The Mills Building

1700 Pennsylvania Avenue, NW
Washington DC

Modification before the Board of Zoning
Adjustment

Board of Zoning Adjustment
District of Columbia
CASE NO. 2019-0003
EXHIBIT NO. 3B

Floor Plan Diagram - Ground Level

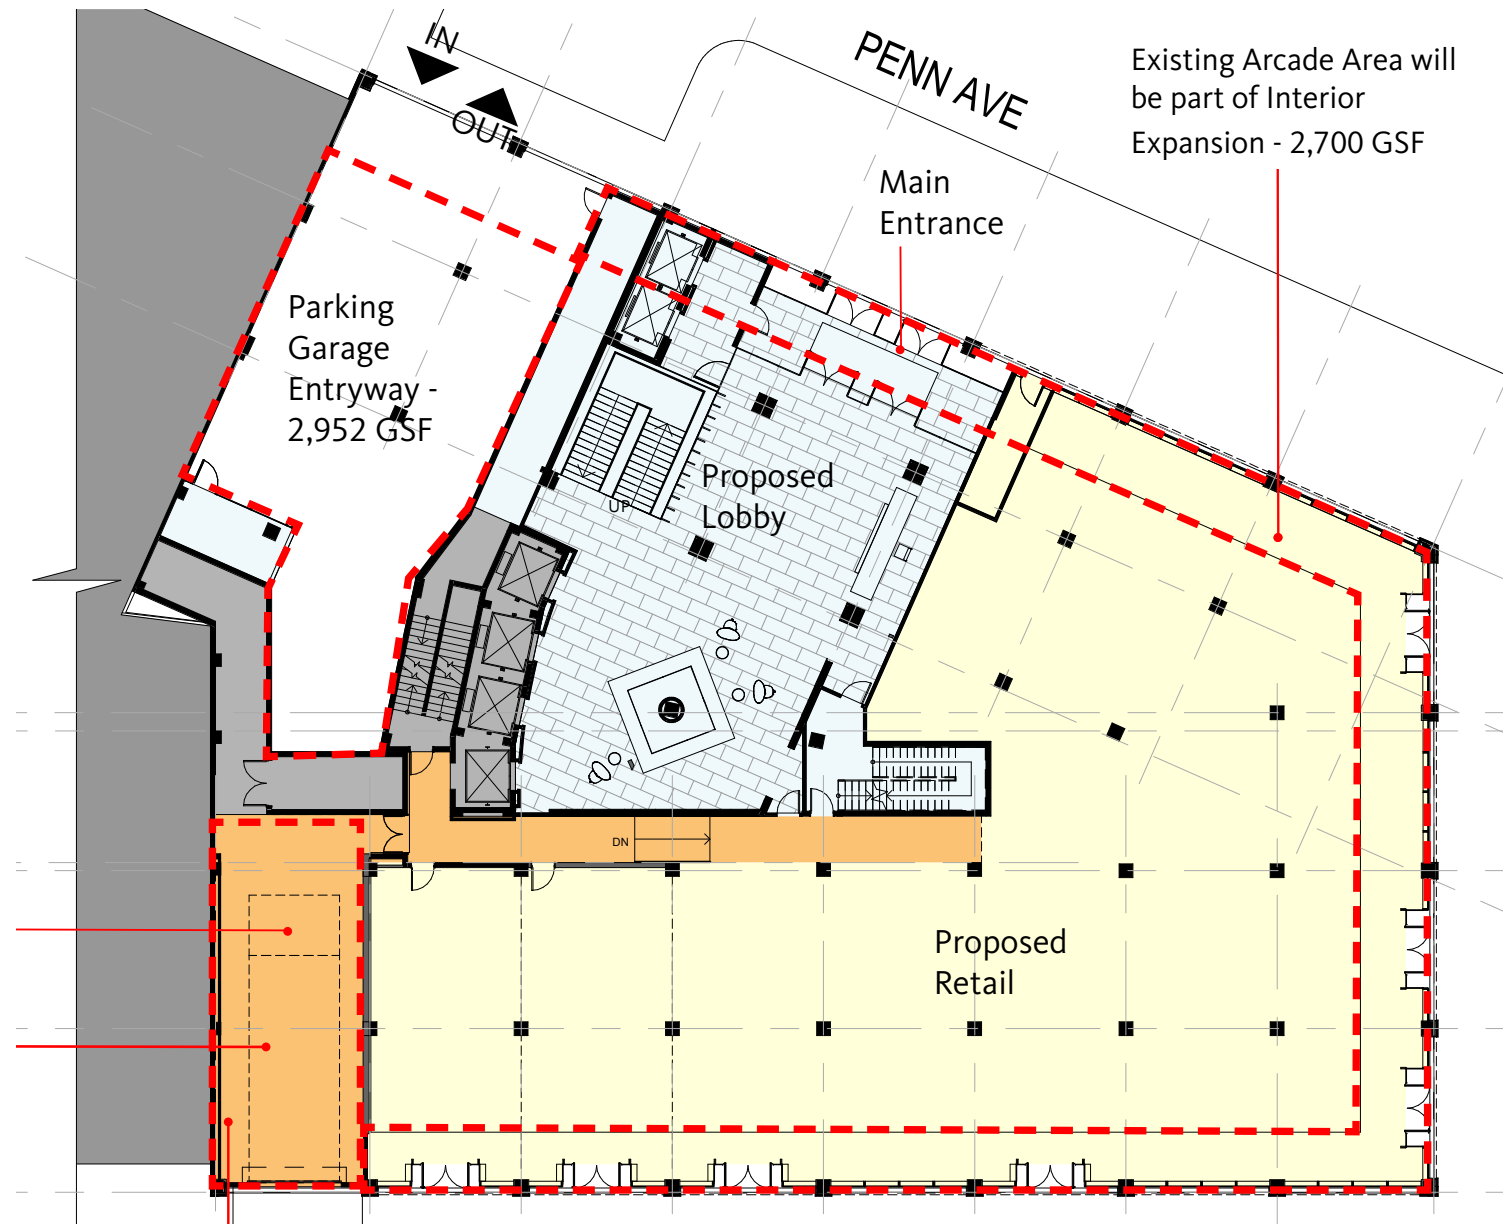
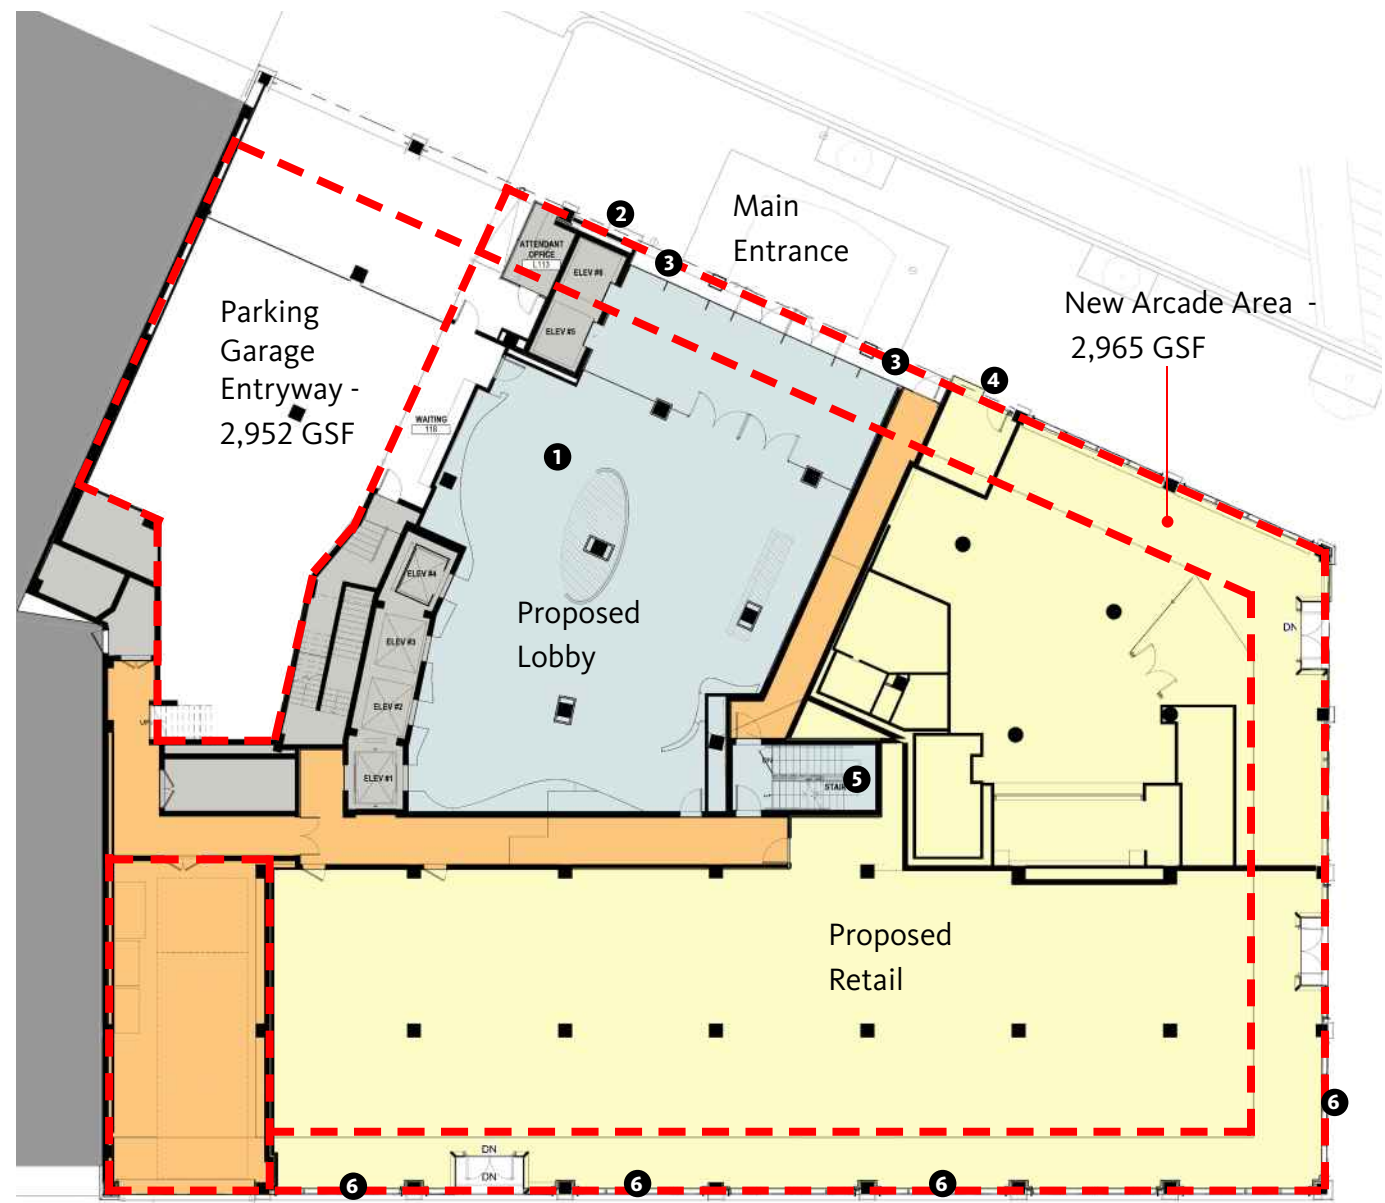
- 1 - Internal lobby stair removed
- 2 - Elevators moved roughly 2" east to coordinate with existing footings
- 3 - Main entrance glazing widened to include shuttle elevator lobby and egress corridor
- 4 - Fire command center revised to code-required dimensions
- 5 - Egress stair shifted slightly and egress corridor added
- 6 - Proposed entrance locations removed

Floor Plan Diagram - Level 2 to Level 8

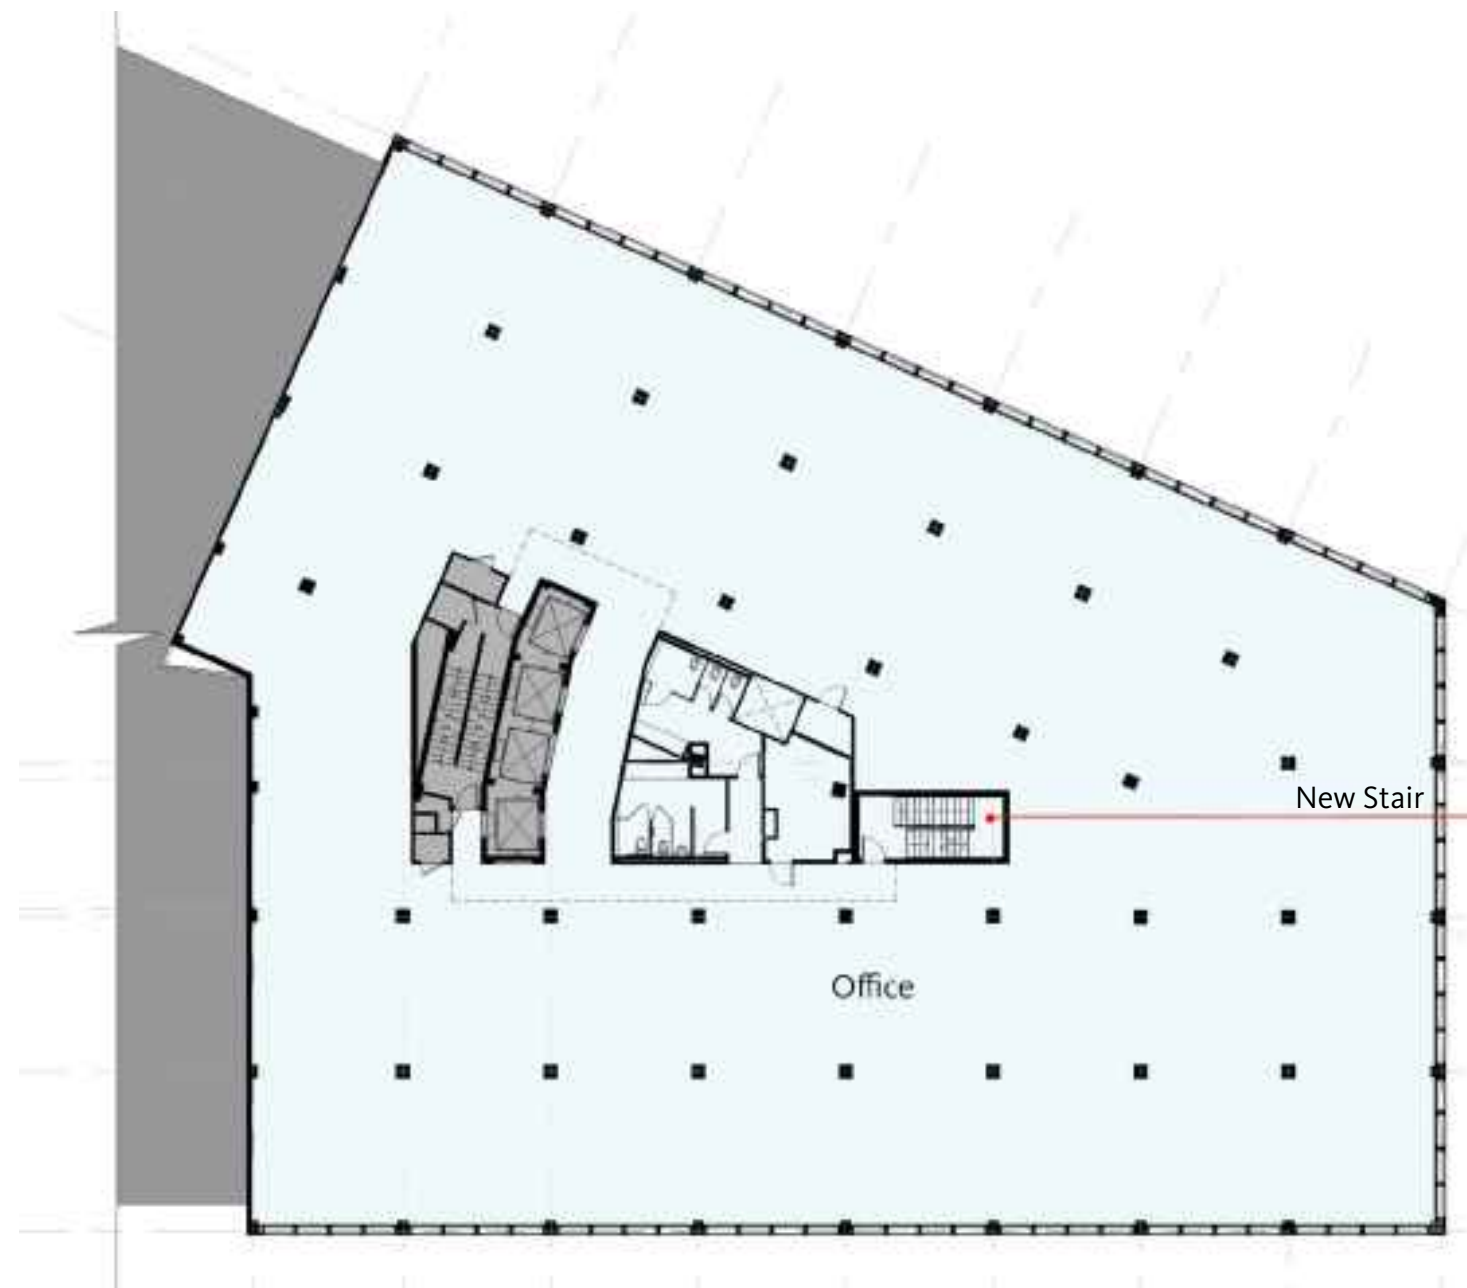
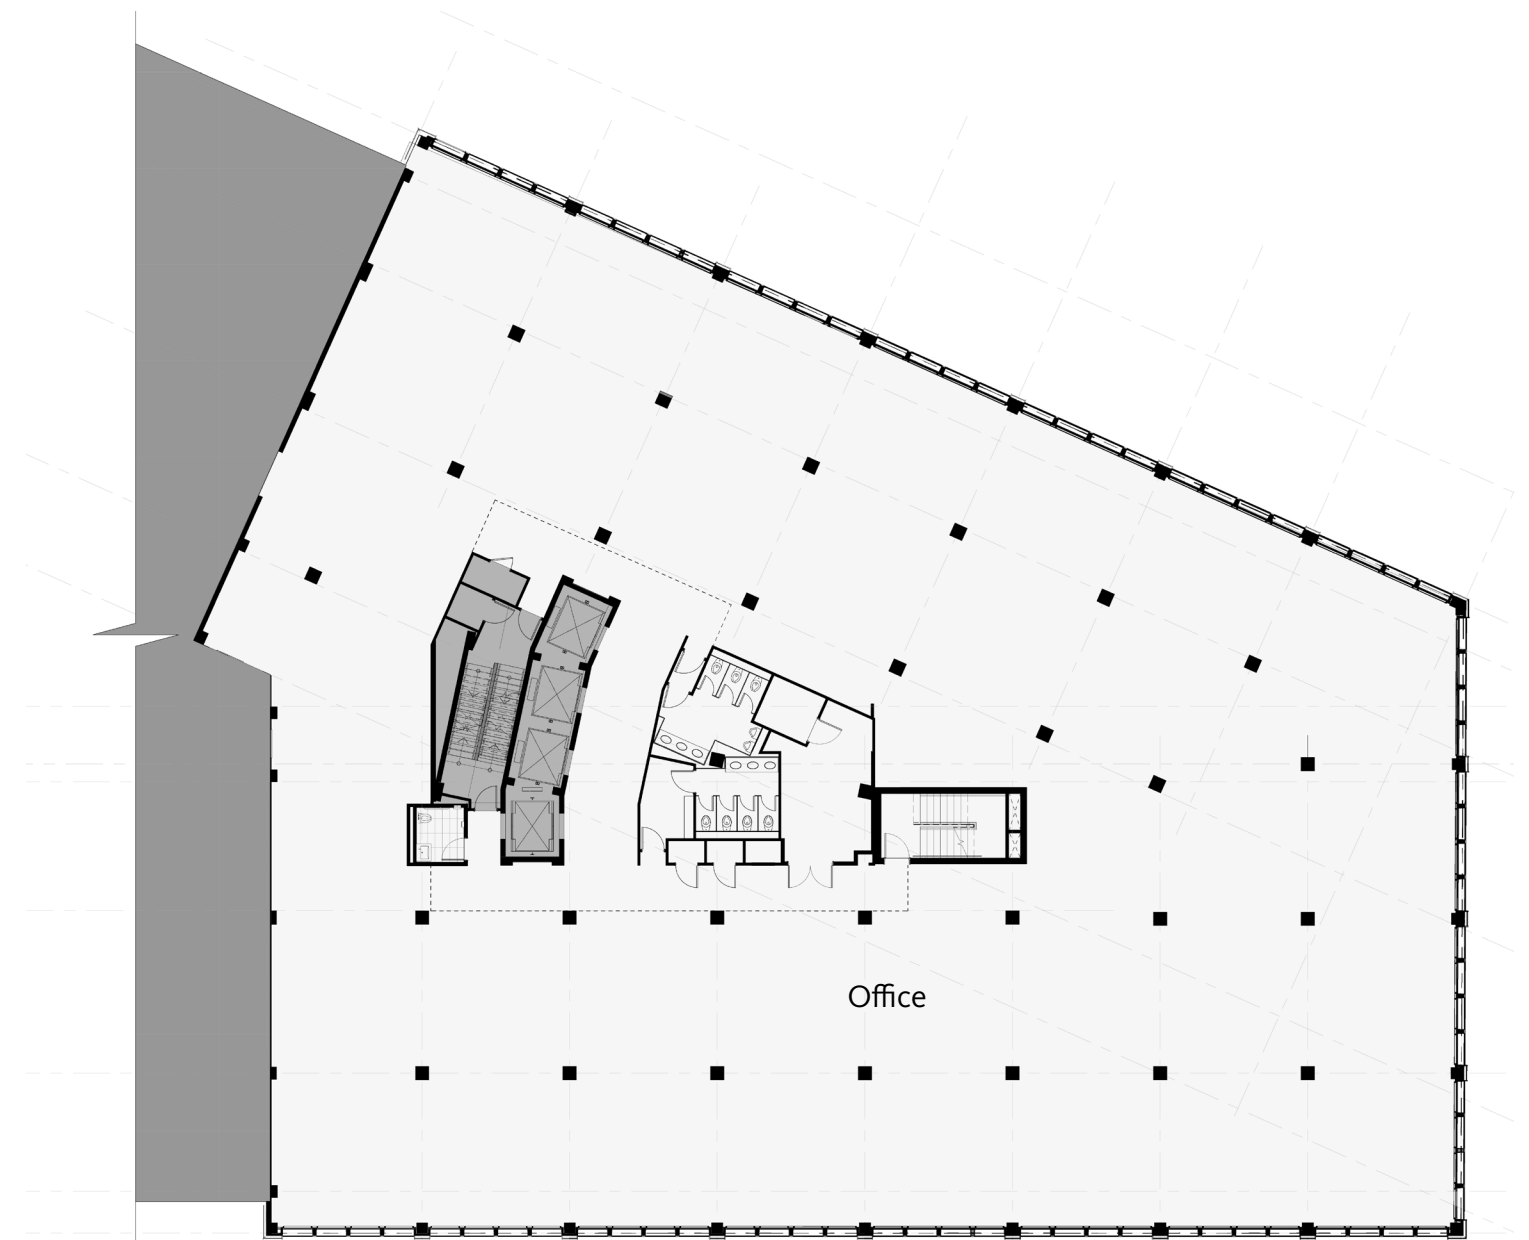
No exterior revisions compared to approved plan.

Interior revisions limited to minor changes to core layout to accommodate existing utility services to remain, new services, and ADA.

Floor Plan Diagram - Level 9

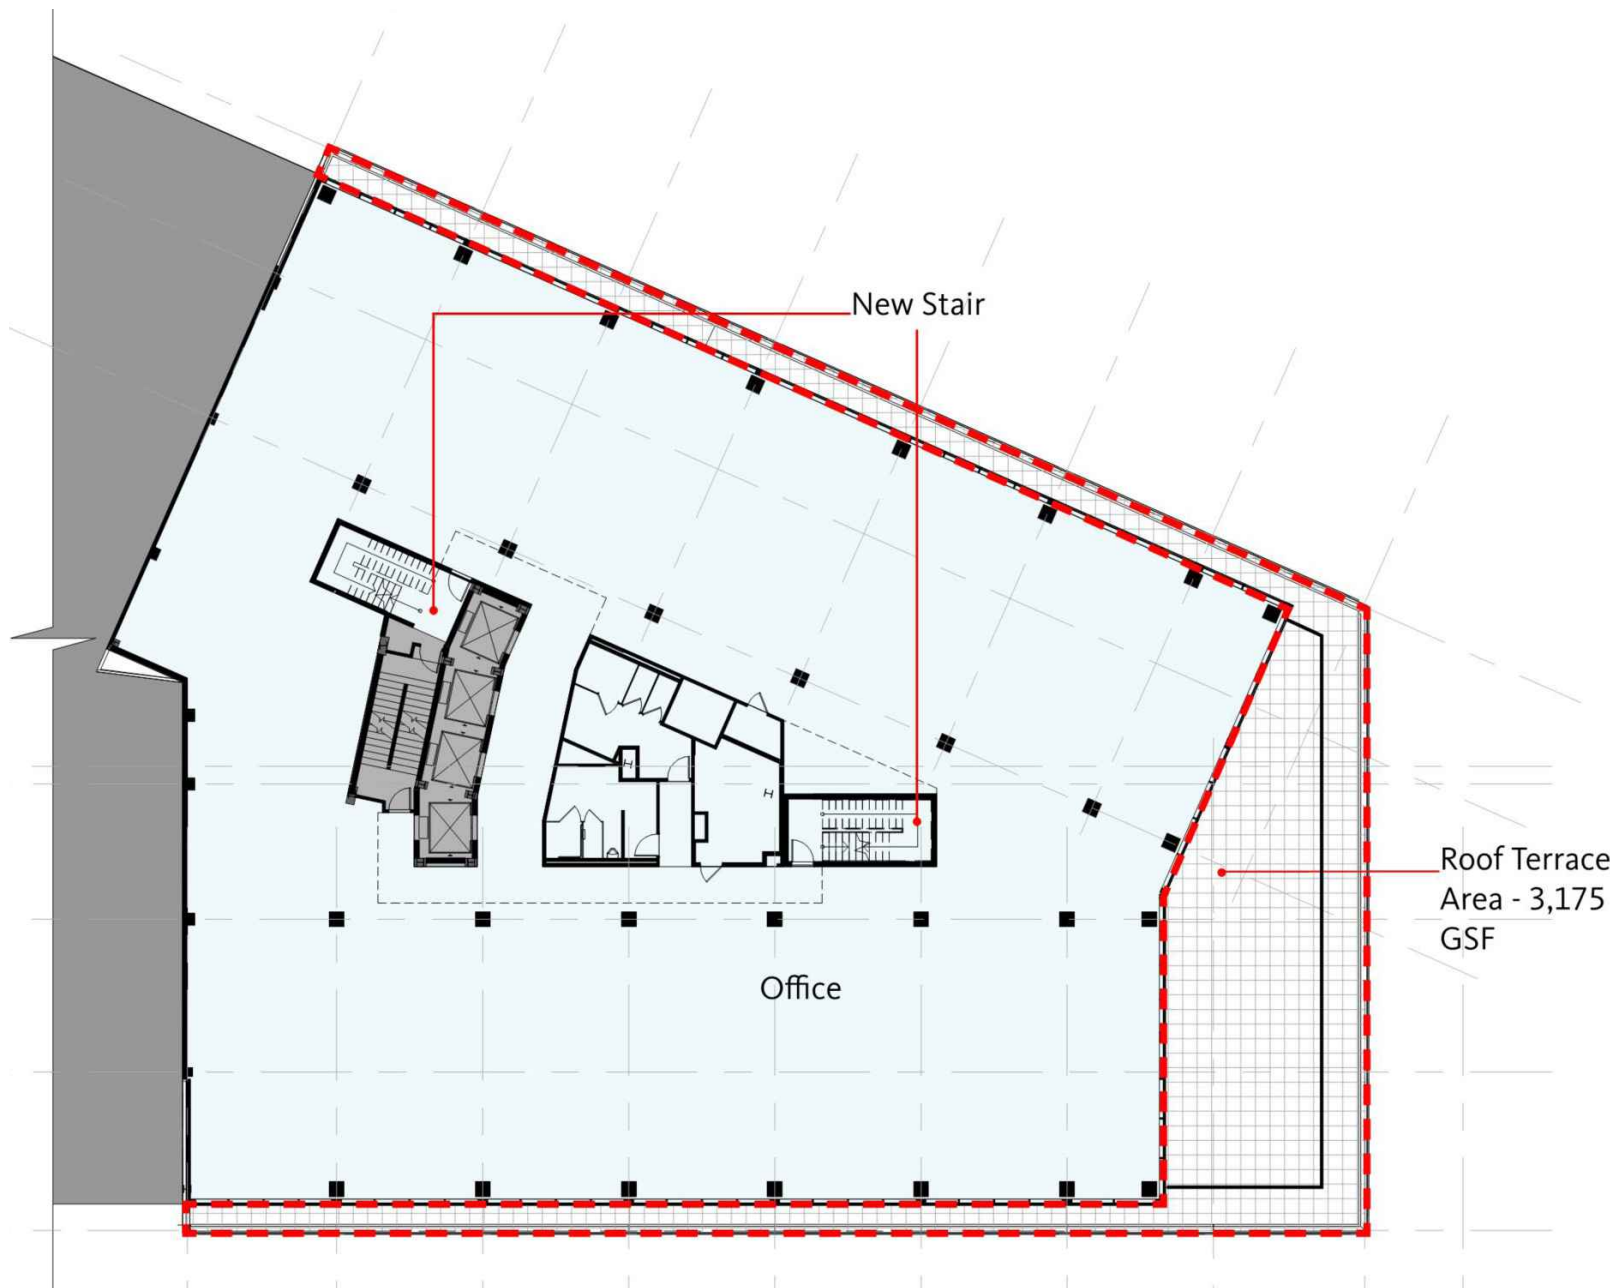
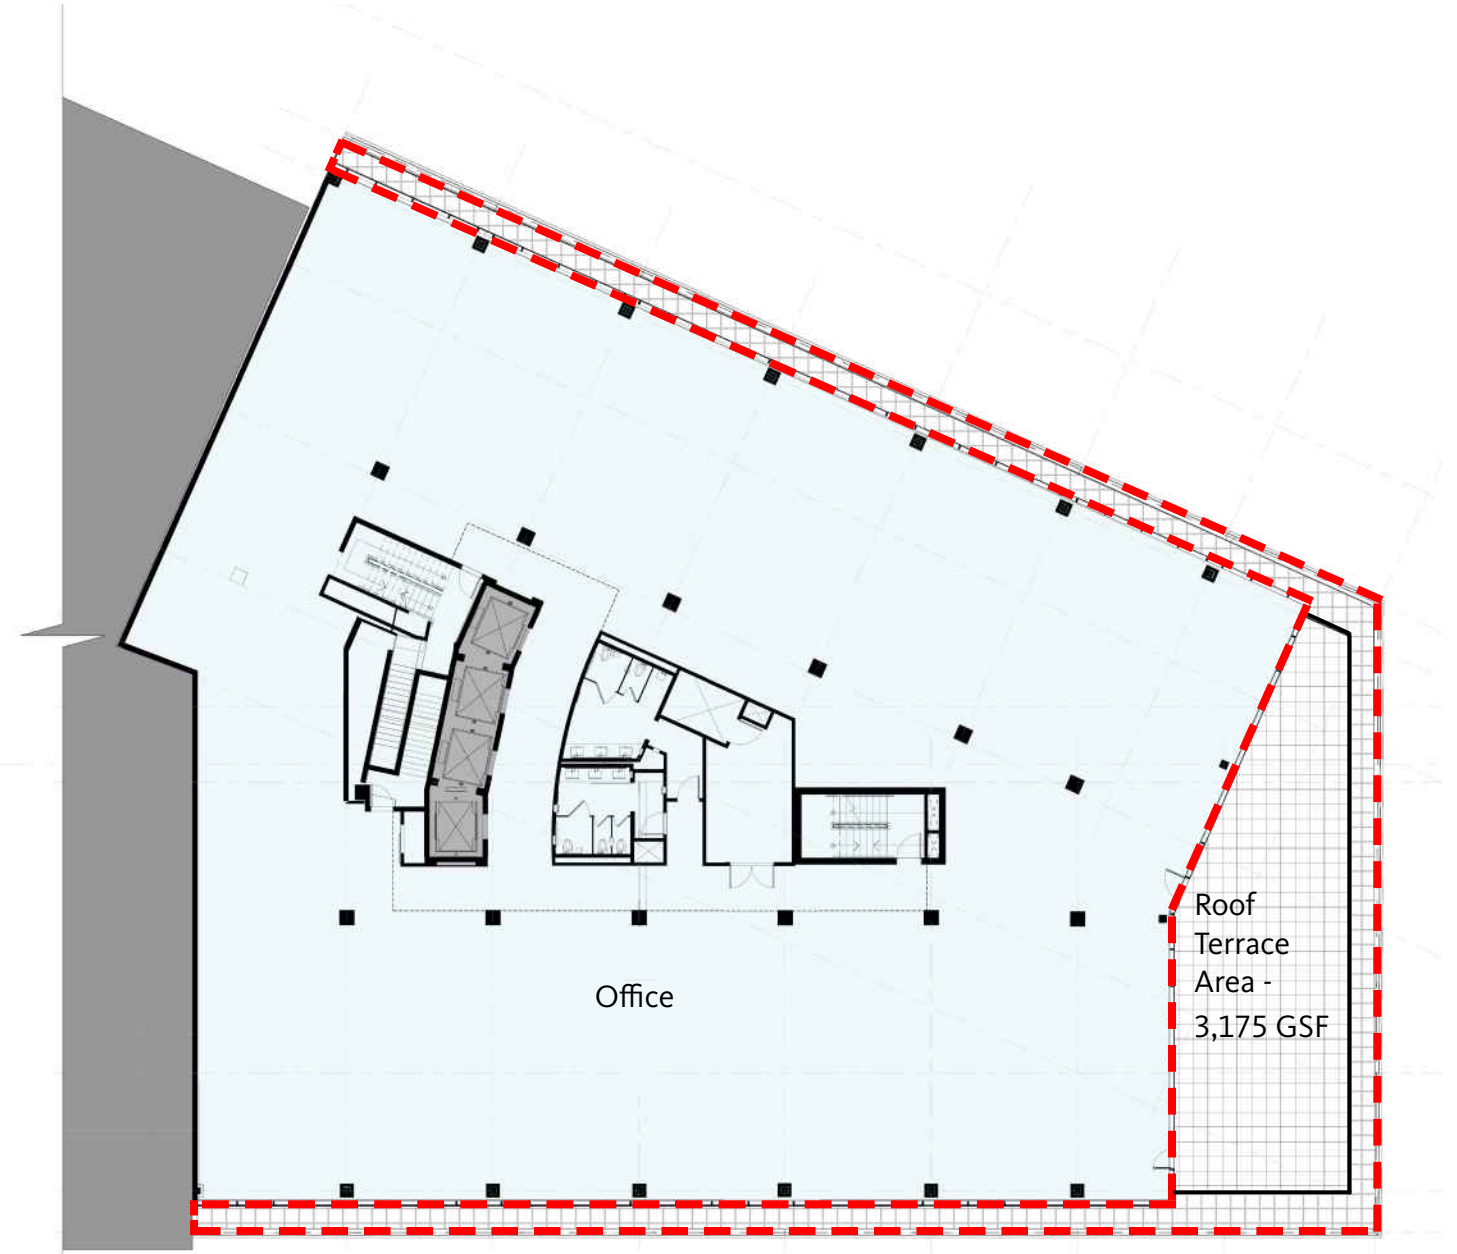
Exterior Revisions limited to facade treatments to satisfy CFA commentary and addition of doors to satisfy egress requirements from Roof Terrace.

Interior revisions limited to minor changes to core layout to accommodate existing utility services to remain, new services, and ADA.
